# Groundwater Transfer Review Summary Form

Transfer/PA # T- 14493

Application: T-14493

Applicant Name: Cheyne Brothers LLC and Lee Sukraw

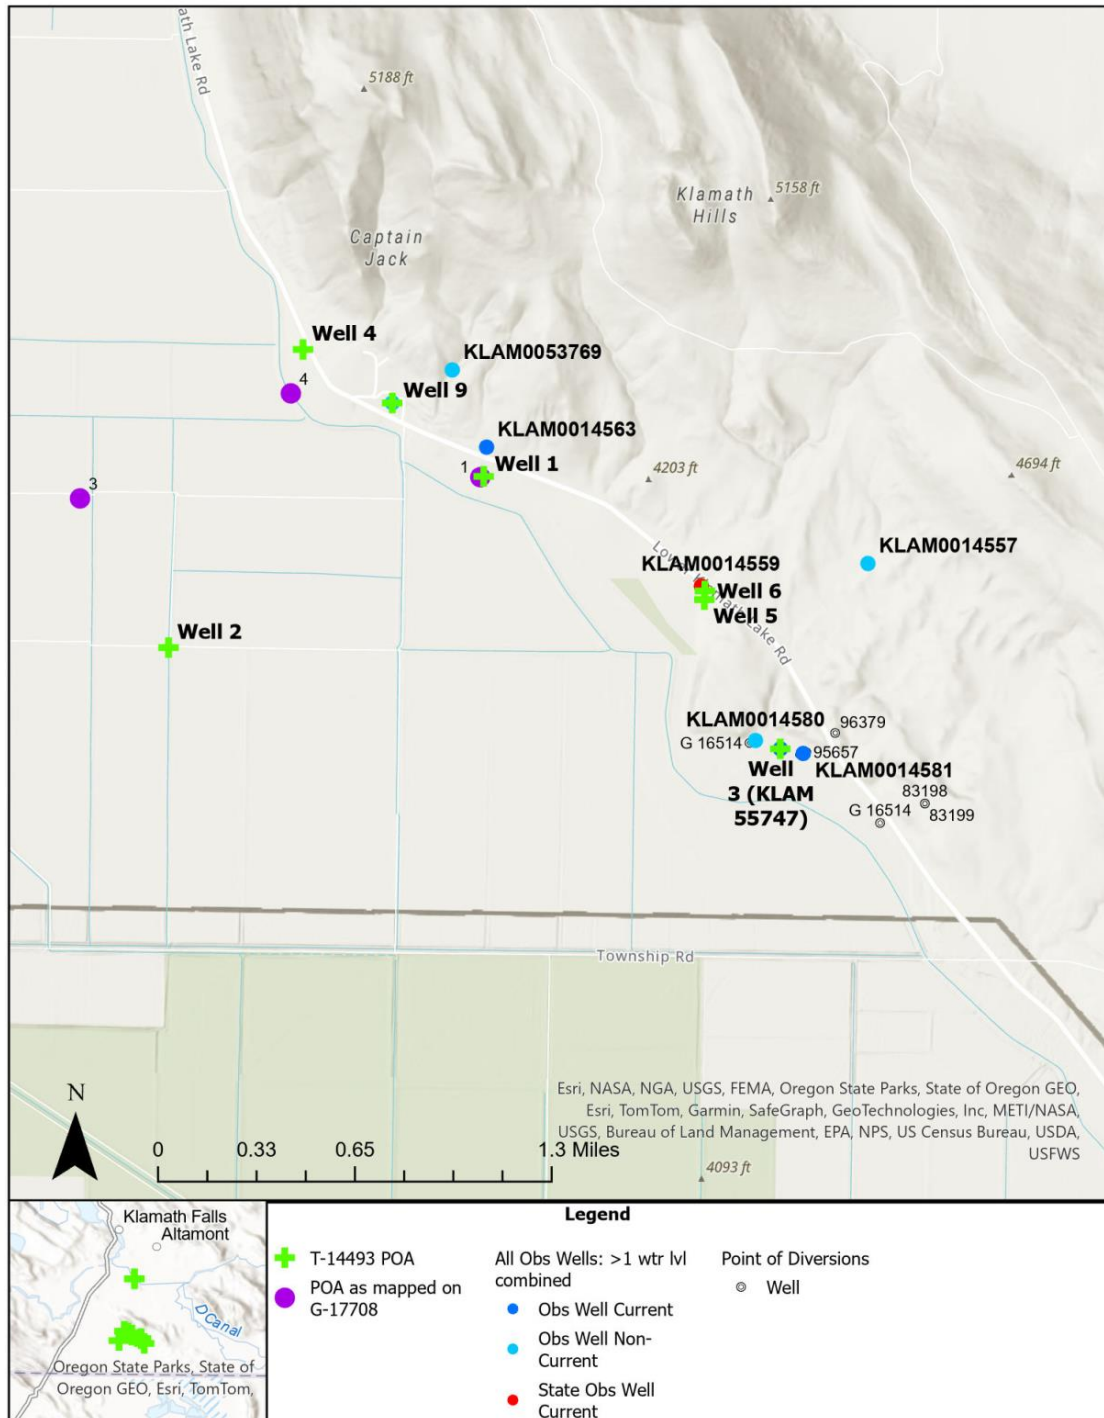
- Change the location of yet to be drilled POA #3 to already drilled well KLAM 55747 located approximately 2.5 miles to the east-southeast of the originally proposed POA. KLAM 55747 is also listed as a groundwater POA for Certificate 95657 and Permit G 16514.
- Correct the locations of POA #1 (KLAM 61795) and POA #4 (KLAM 61160).
- There also appear to be minor corrections in locations for POA #5, #7, #8, and #9.
